Service Bulletin

Bulletin No. 2009-73R1
CMD 2009-13R1

Service Replacement for One-Piece Anodes on Zeus Trim Tabs Models Affected

Models Covered	Serial Number
All Zeus pod drives	0M957858 to 0M963370

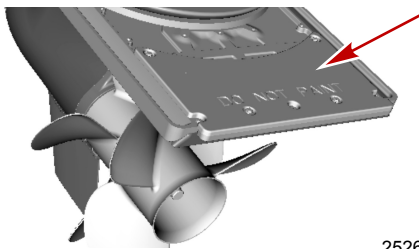
The sacrificial anode located on the trim tab of the Zeus drive was changed from a large one-piece anode to a more service-friendly two-piece anode.

One-piece anode

Two-piece anode

The new two-piece anode replaces the one-piece anode. The installation of the two-piece anode requires a drilling fixture to locate the new anodes properly on the trim tab.
